HANNAH RIDGE AT FEATHERGRASS FILING NO. 5

CONSTRUCTION PLANS

HANNAH RIDGE AT FEATHERGRASS
FILING NO. 5, 6 & 7
OVERLOT GRADING AND EROSION CONTROL PLAN

DESIGNED BY	KRC	SCALE	DATE	10/12/18
DRAWN BY	KC	(H) 1" = 50'	SHEET	2 OF 11
CHECKED BY	(V)	1" = NA	JOB NO.	1116.05

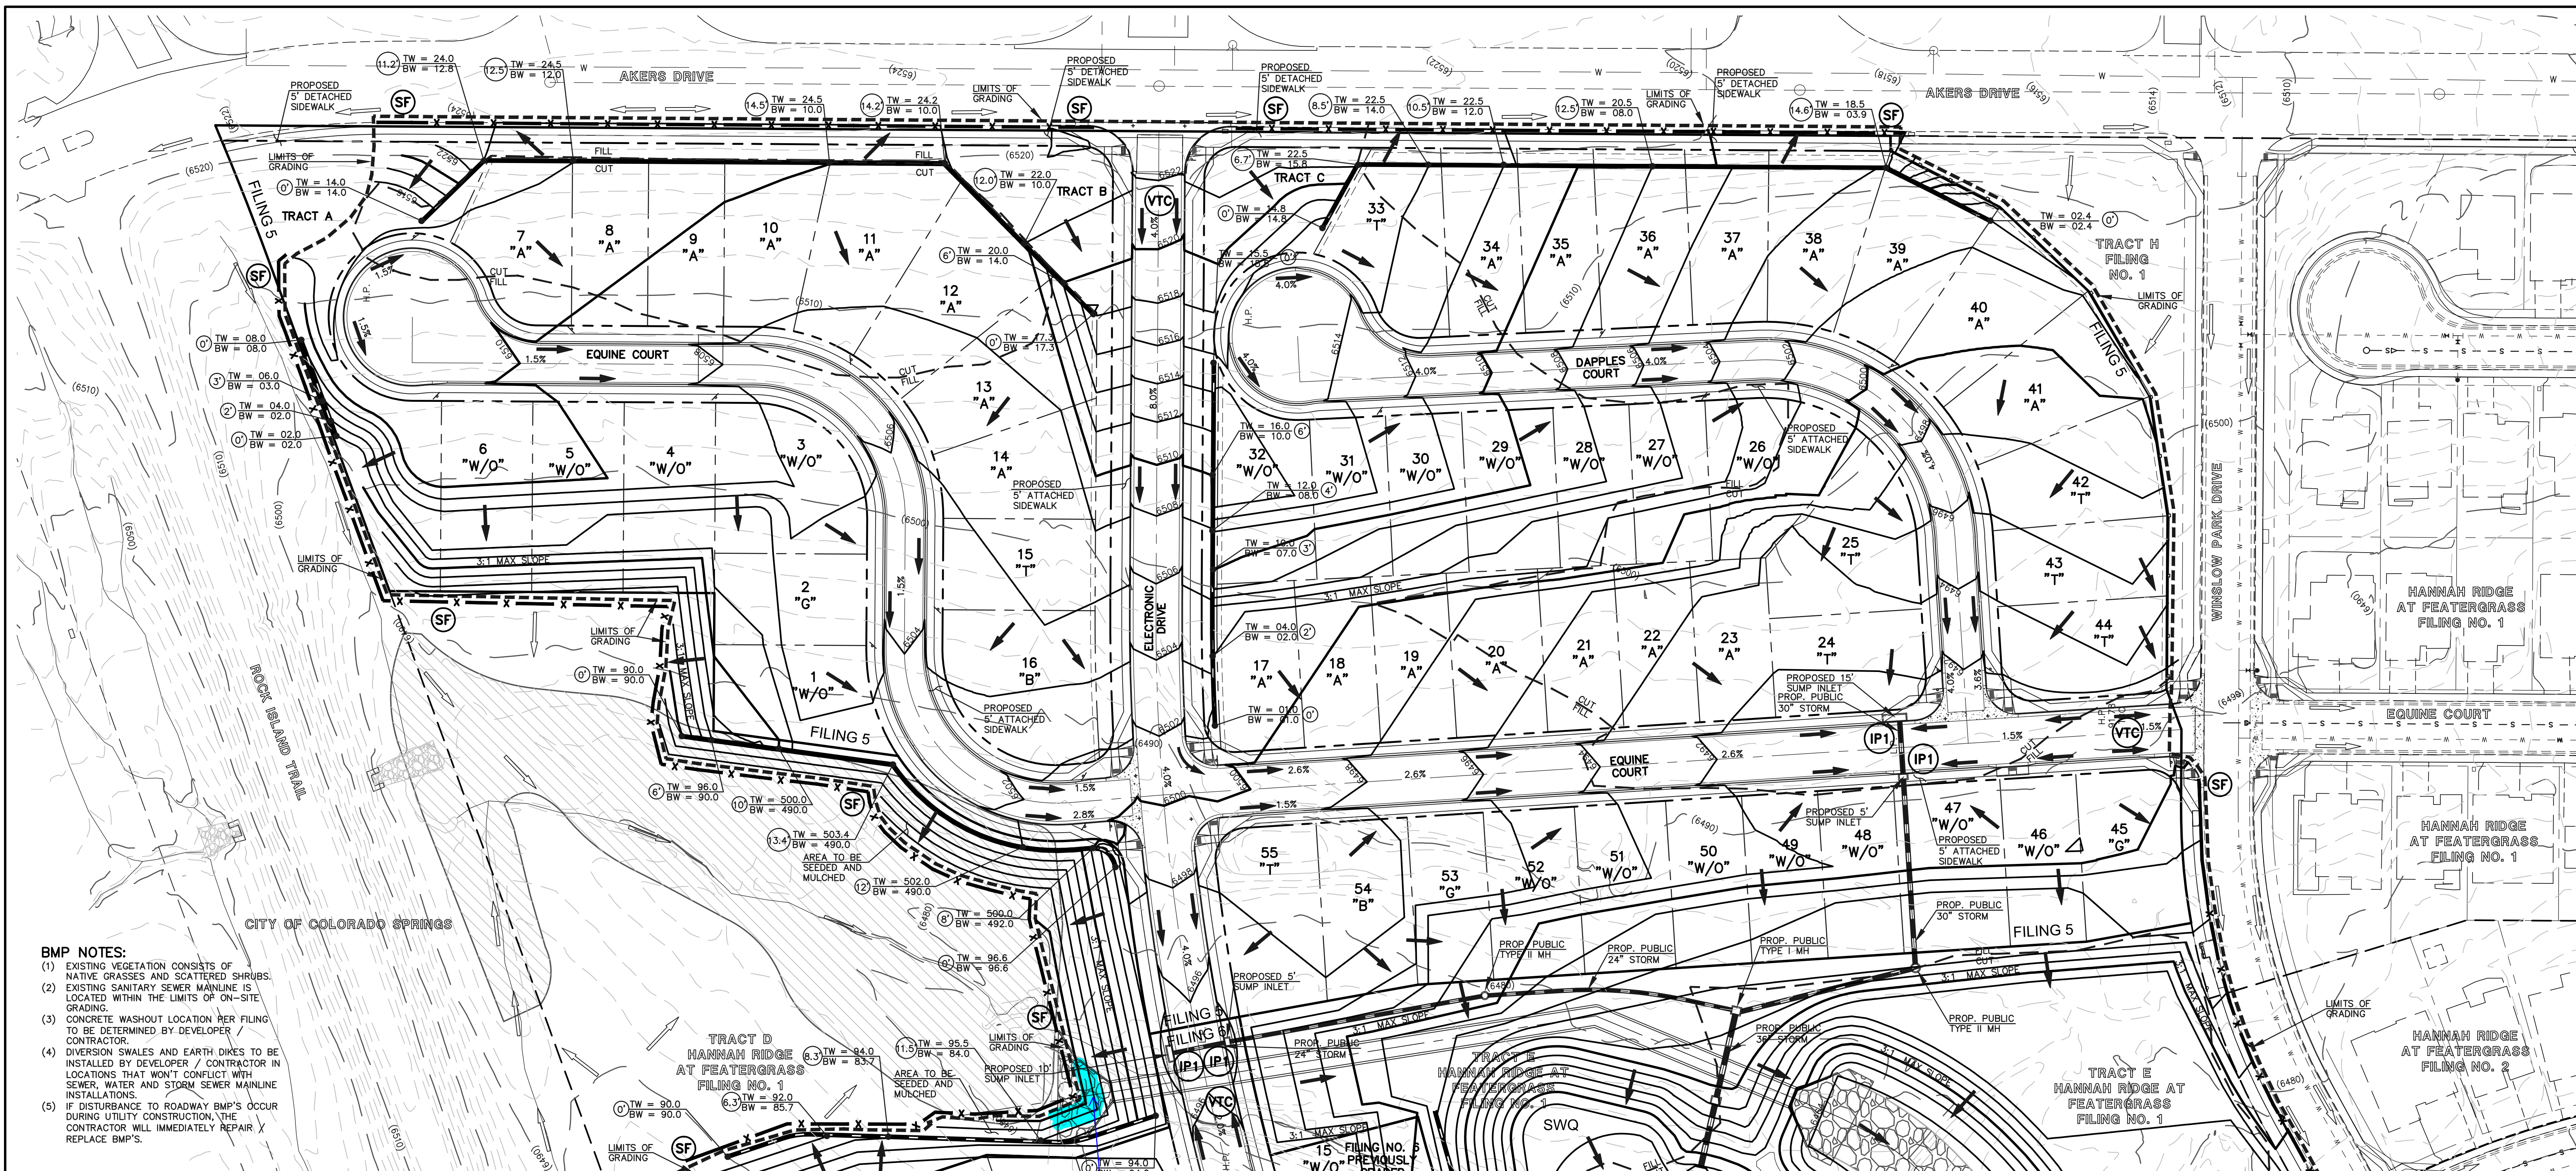
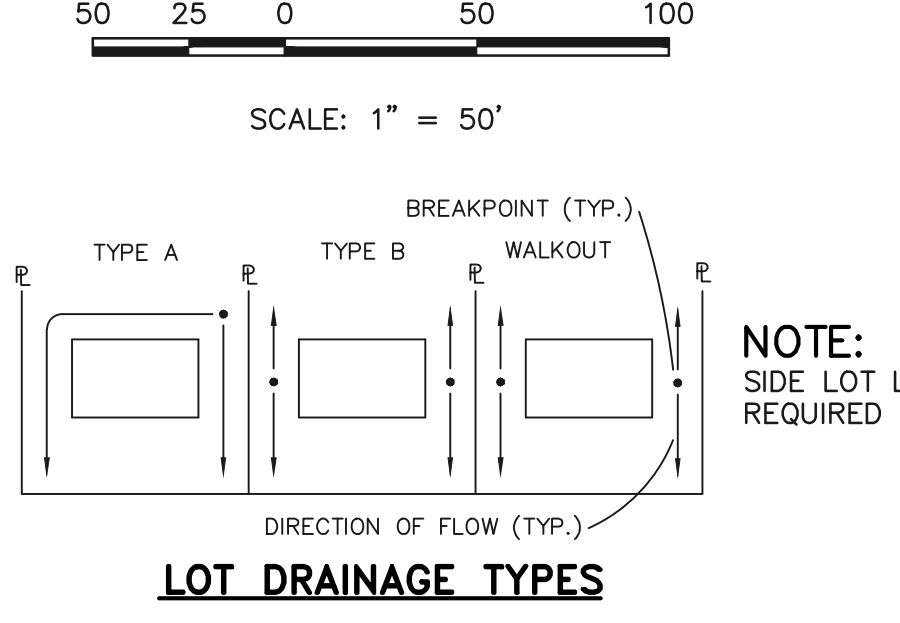
Final grading contours are on top of the box culvert end section and rip rap. This implies that they are buried. Please correct this.

Please add a note on the cover the GEC plans, SWMP plans etc. Will the SWQ facility be utilized as a sediment trap initially? then later after the site is stabilized and portions of the housing is complete the SWQ facility will be finalized? please clarify. Only one Sediment trap is called out on the FAE?
